Case #
EH-PLANS-24-0

Application Name
B24004539

Description
SFD/ Construct Pre manufactured garage, 12x28, placed on 4" based of crushed stone, 1 STORY, Existing, 0R, 0FB, 0HB, 0FP, OTHER STRUCTURE = None, 0BR, PORCH/DECK = N/A, ENERGY METHOD = N/A,

Schrider Permit Number # B24004539

LOCATION DRAWING
K.D. AND B.L. MAUCK PROPERTY
LIBER 8434 FOLIO 143
1660 SCHAFFERSVILLE ROAD
NEAR MOUNT AIRY
HOWARD COUNTY, MARYLAND

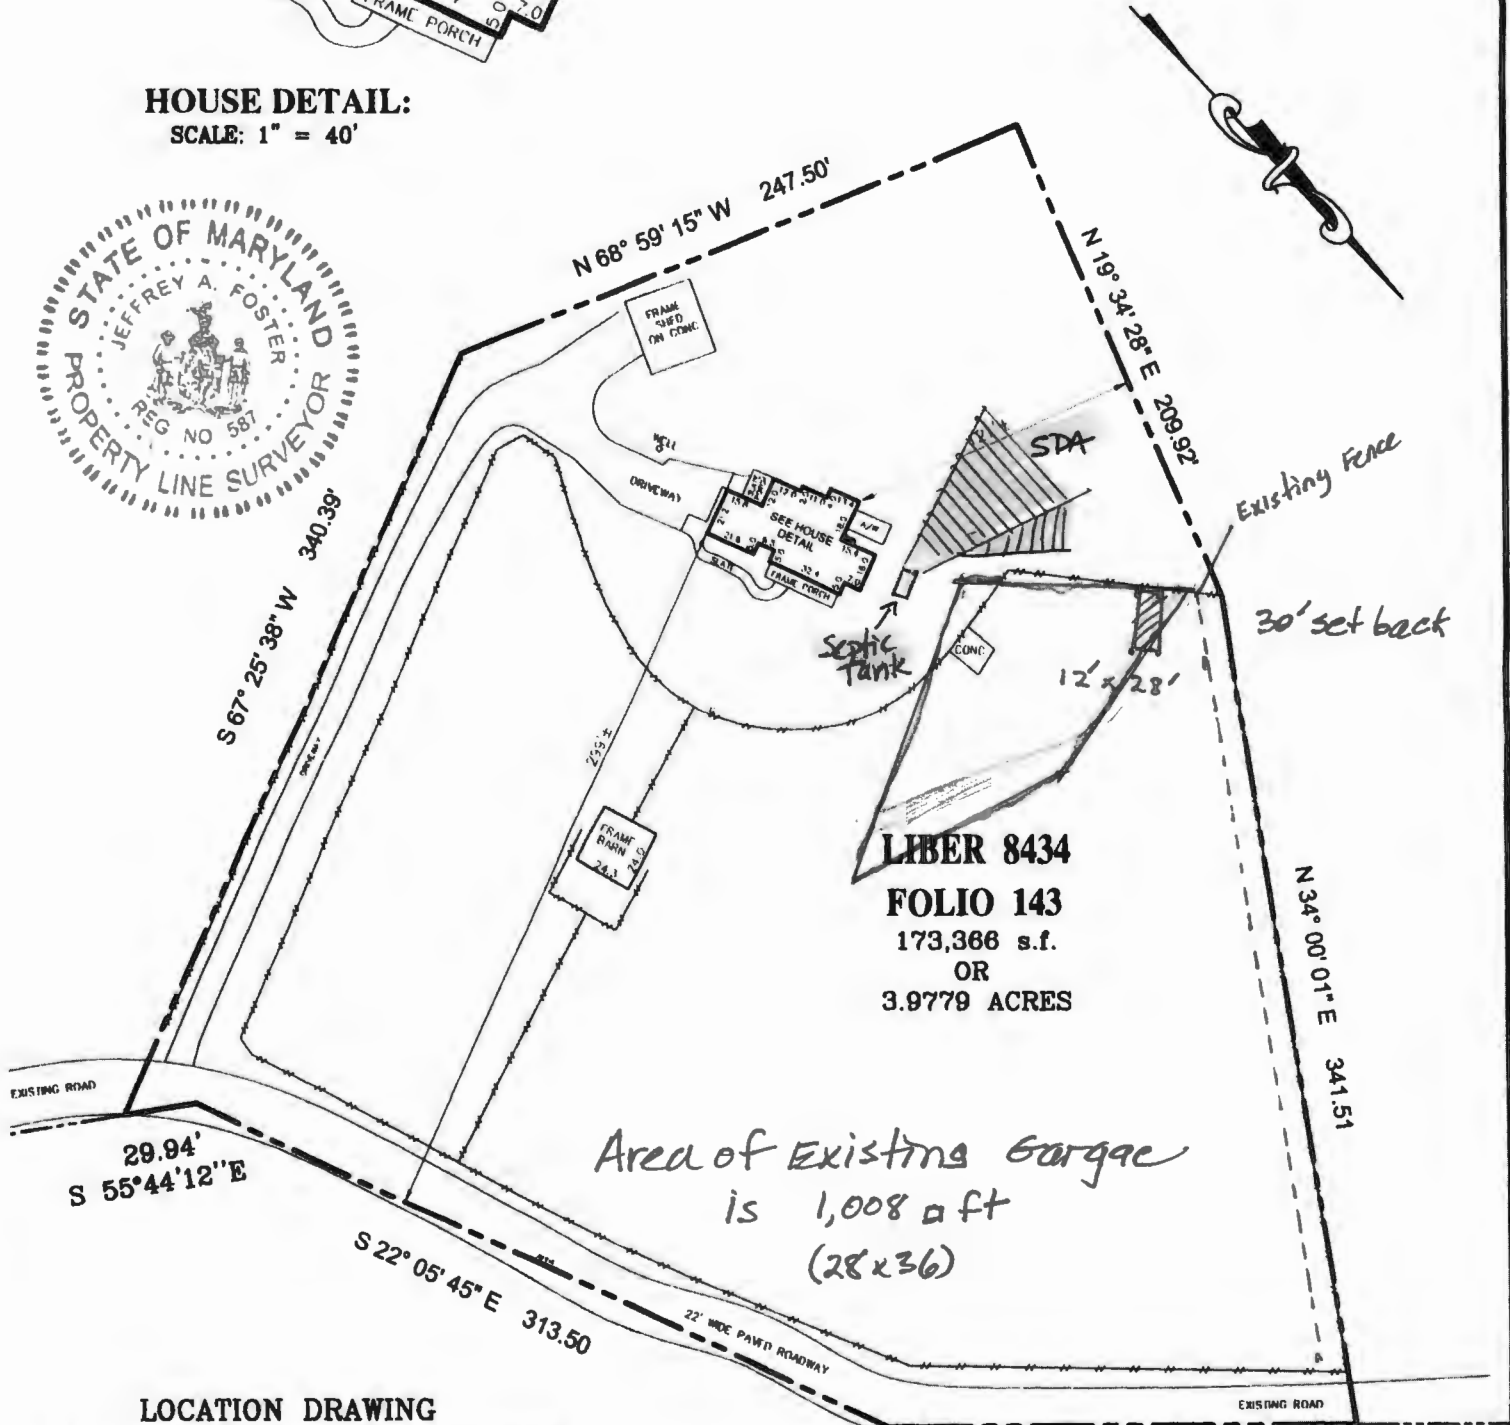
See attached revised plat showing the location of the existing septic tank and field (SDA). The location of the proposed pre-fab garage. The location of the garage is approximately 100 feet from the septic tank and approximately 50 feet from the SDA.

On your most recent site plan, the SDA was not accurately shown based on the 2018 site plan. In addition, the proposed garage appears to be inside the SDA.

With that said, you may either revise the site plan to show the SDA in the correct location and proposed garage meeting the required 20 foot setback distance, or you may contact an engineer to revise the location of the SDA on a perc cert plan. The later will most likely require additional perc testing.

HOUSE DETAIL:
SCALE: 1" = 40'

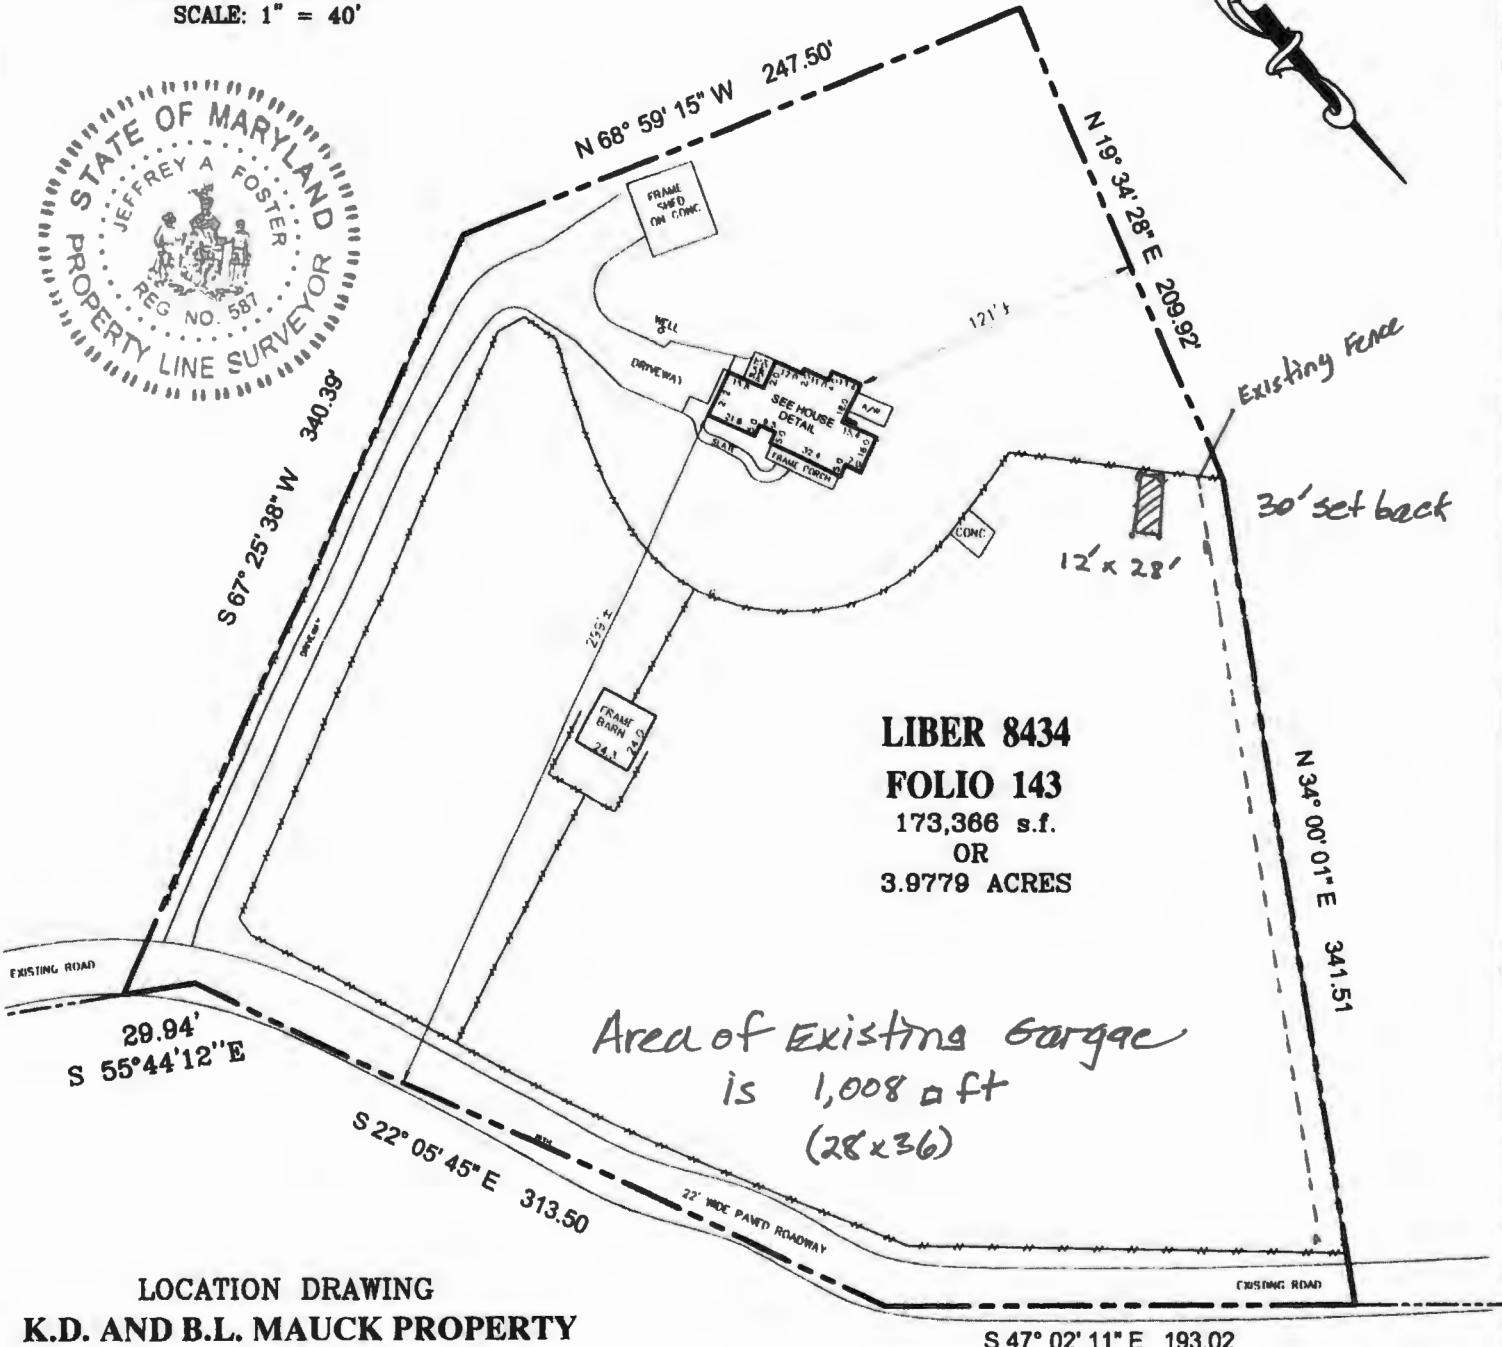
Thank you for the updated site plan. On a previous building permit in 2018, the sewage disposal area (SDA) was documented and approved on a site plan. Please see attached site plan with location of the SDA.
